V2500-A1/A5/D5 PROPULSION SYSTEM SERVICE BULLETIN

This document transmits the Initial Issue of Service Bulletin EV2500-70-0784

V2500-ENG-70-0784 ENGINE - OIL PART NUMBER CORRECTION

Oil scavenge tube
Fig 1 sheet 1

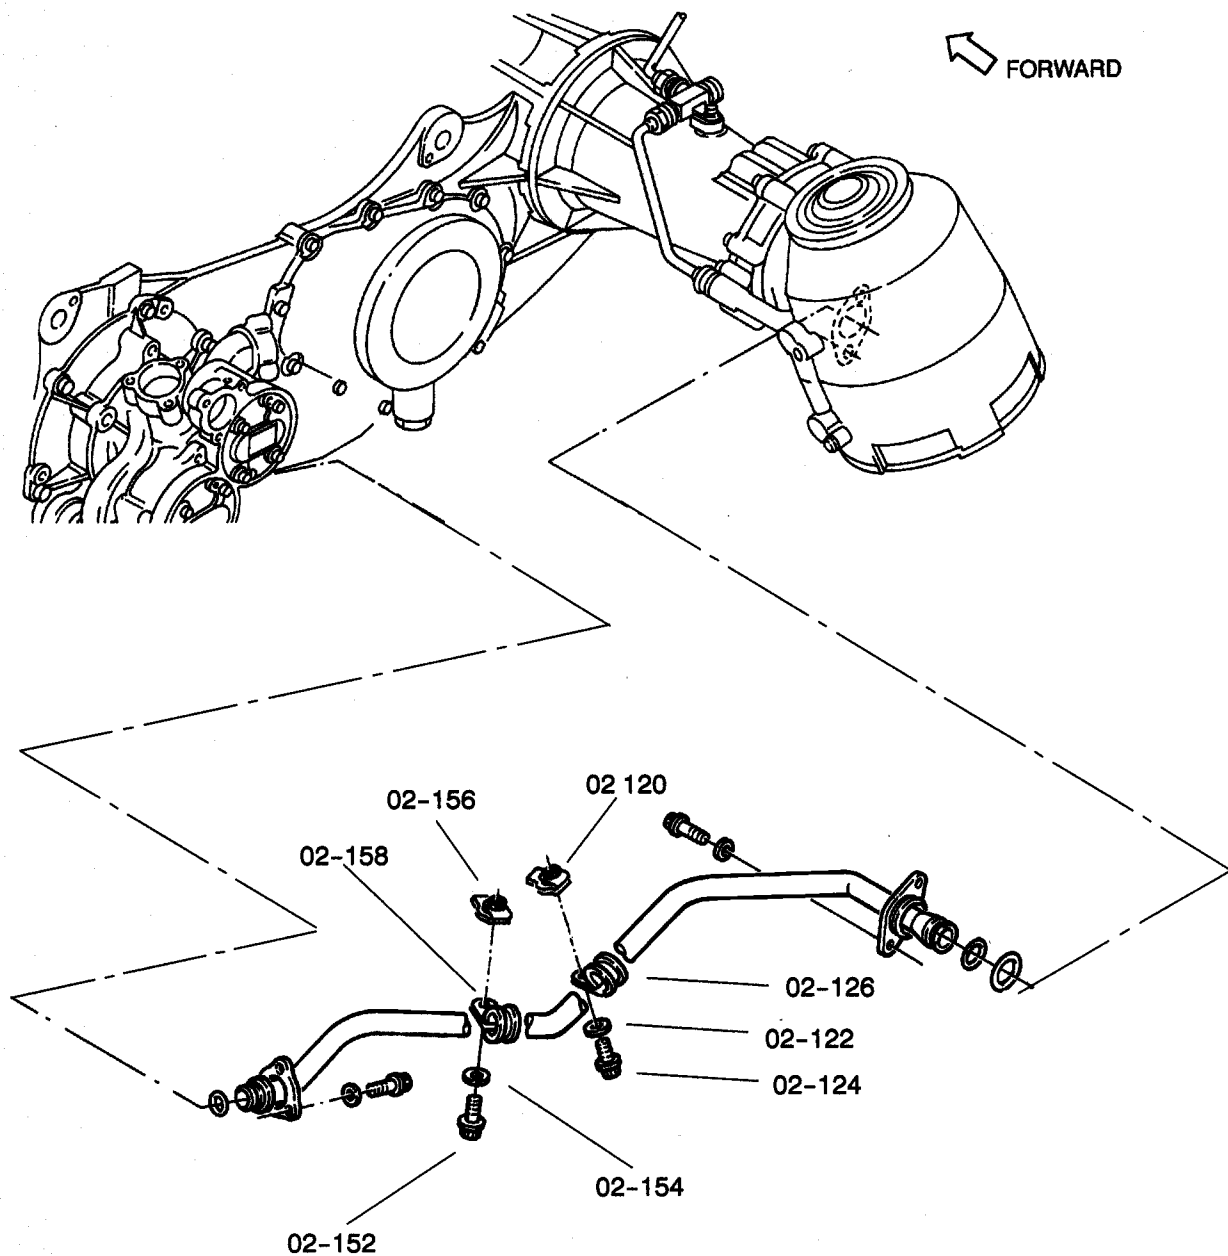
To change an incorrect part number. To move some parts from the actual position (fig. item) to a new position, See Fig. 1 sheet 1. To correct the quantity of some items. See Fig. 1 sheet 2.

CHANGE FIG. ITEM AND QTY
FROM 04-145, QTY 2
TO 04-160, QTY 1

CHANGE FIG. ITEM AND QTY
FROM 04-137 QTY 2
TO 04-152 QTY 1

CHANGE FIG. ITEM AND QTY
FROM 04-135 QTY 2
TO 04-150 QTY 1

CHANGE QTY
FROM 04-135 QTY 2
TO 04-135 QTY 1

CHANGE QTY
FROM 04-137 QTY 2
TO 04-145, QTY 1

CHANGE QTY
FROM 04-145 QTY 2
TO 04-145 QTY 1

CHANGE FIG. ITEM AND QTY
FROM 04-140 QTY 2
TO 04-155 QTY 1

CHANGE QTY
FROM 04-140 QTY 2
TO 04-140 QTY 1
